Office Action Summary

10/523,768

JOHANN ROBERT

Fig. 2

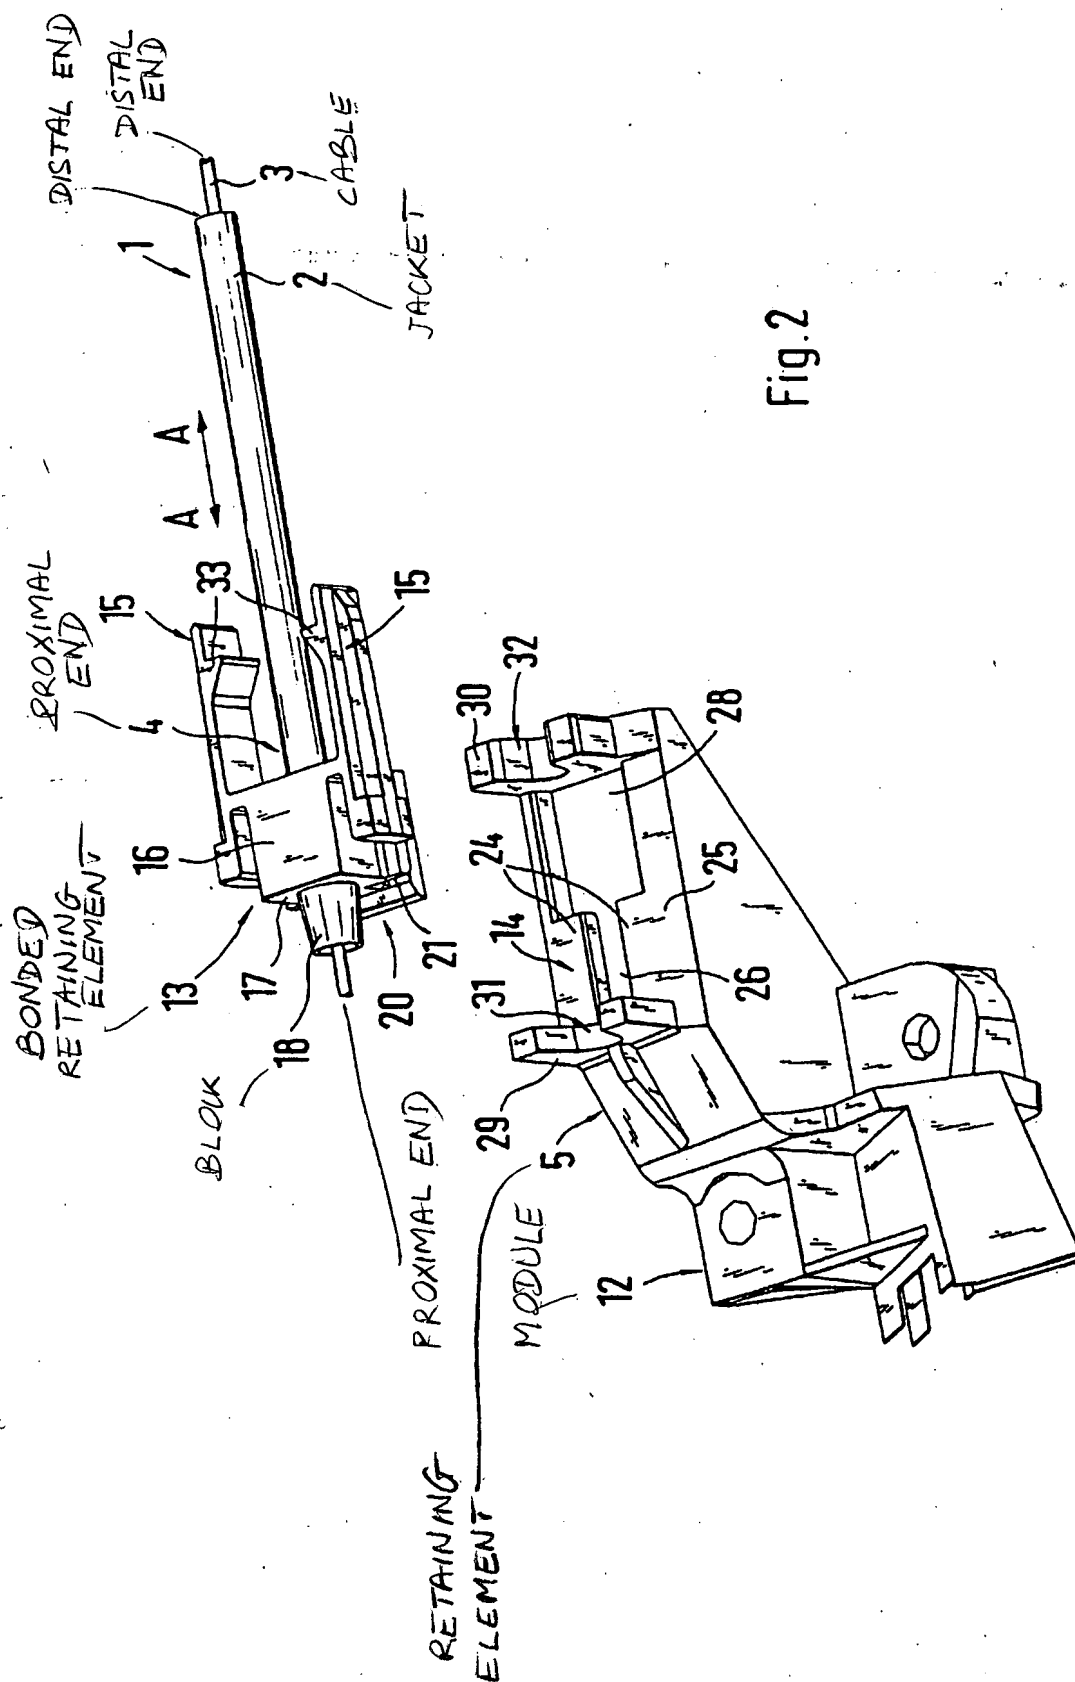
Regarding Claim 1, Gutschner teaches a control device for a module 12 forming a lock mechanism, of the type comprising a Bowden-type cable containing a cable 3 having two ends, a proximal end (see Attachment hereinafter "Att.") and a distal end (Att.) respectively, this cable 3 being housed in a jacket 2 having two ends, a proximal end 14 and a distal end (Att.) respectively, which are immobilized by two proximal and distal retaining elements 13 and 5, characterized in that *at least* one of the ends of the jacket 2 is connected to the corresponding retaining element 13 by adhesive bonding (*i.e.*, gluing. *Ibid.* col. 2, lines 61-64), the bonded retaining element 13 being provided with a part 16 forming a sleeve 16 for fitting the bonded end 4 of the jacket 2, the sleeve-forming part 16 containing an orifice (FIG. 4 of Att.) which is substantially transverse to the direction in which the bonded end 4 of the jacket 2 is fitted, this orifice (FIG. 4 of Att.) forming a receptacle (FIGS. 4 and 6) *for* holding a mass of adhesive in contact with the jacket 2 and the bonded retaining element 13.

Regarding Claim 6, the proximal end (FIG. 2 of Att.) of the cable 3 is provided with a block 18 for securing this cable 3, the shell 20, 27 forming a housing for this securing block 18.

Regarding Claim 9, Gutschner teaches a method of adjusting a Bowden-type cable containing a cable 3 having two ends, a proximal end (FIG. 2 of Att.) and a distal end (Att.) respectively, this cable 3 being housed in a jacket 2 having two ends, a proximal end 4 (Att.) and a distal end (Att.) respectively, this jacket 2 being *intended to be* immobilized by two proximal 13 and distal 5 retaining elements, characterized in that: the length of the proximal end (Att.) of the cable 3 protruding outside the jacket 2 through the proximal end 4 of the latter is adjusted, then the proximal end 4 of the jacket 2 is fastened to the proximal retaining element 13 by adhesive bonding. *Ibid.* col. 2, lines 51-64 and Claims 1-4.

Fig.4

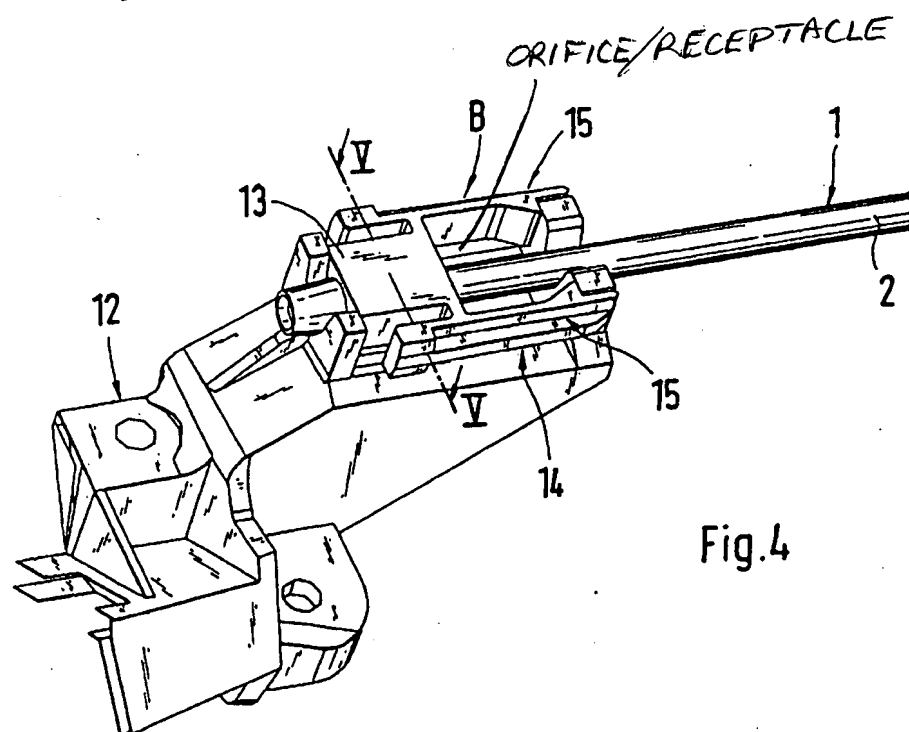
Regarding Claim 4, the edges of the orifice (FIGS. 4 and 6) are provided with projecting or recessed reliefs 33.
